## Access Compliance Report Public Rights-of-Way (Curb Ramps)

Intersection ID: 24614Main Street:BECKMORE\_PLCross Street:PINEVILLE-MATTHEWS\_RDLocation:NEADA ID: EBF1CF4E0D15Ramp Type:PerpInitial Pass/Fail:FailOverall Compliance:NoSeverity Score:12.5

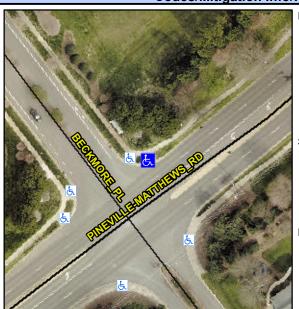
Possible Solution			
Possible Solutions:	C		
Remove & Replace Entire Ramp.			
•	Ye		
	N/		
Surveyor Notes:	N/		
N/A	N/		
	N/		
	N/		
	N/		
PROW/ADA:	N/		
Not Found, R304.2.2	N/		
·	N/		
	N/

Field Measurements/Component Compliance						
Compl	iance Description	Data	Comp	liance Description	Data	
N/A	Ramp Length (in)	96.0	No	Ramp Slope (%)	8.8	
Yes	Ramp Width (in)	48.0	Yes	Ramp XSlope (%)	1.3	
N/A	Flare Type LT	N/A	N/A	Flare Type RT	N/A	
N/A	Flare Slope LT (%)	N/A	N/A	Flare Slope RT (%)	N/A	
N/A	Flare Traversable LT?	N/A	N/A	Flare Traversable RT?	N/A	
N/A	Landing Length (in)	N/A	N/A	DWS Provided?	N/A	
N/A	Landing Width (in)	N/A	N/A	DWS Contrast?	N/A	
N/A	Landing Slope (%)	N/A	N/A	DWS Length (in)	N/A	
N/A	Landing X Slope (%)	N/A	N/A	DWS Full Width?	N/A	
N/A	Landing Curb? (Y/N)	N/A	N/A	DWS Offset (in)	N/A	
N/A	Shared Landing?	N/A				
N/A	Gutter Ponding?	N/A	N/A	Gutter Slope (%)	N/A	
N/A	Gutter Lip Ht (in)	N/A	N/A	Gutter X Slope (%)	N/A	
N/A	Painted X Walk1?	No	N/A	Painted X Walk2?	N/A	
	X Walk 1 Direction	To S		X Walk 2 Direction	N/A	
N/A	X Walk 1 Width (in)	N/A	N/A	X Walk 2 Width (in)	N/A	
	X Walk 1 Slope (%)	1.4		X Walk 2 Slope (%)	N/A
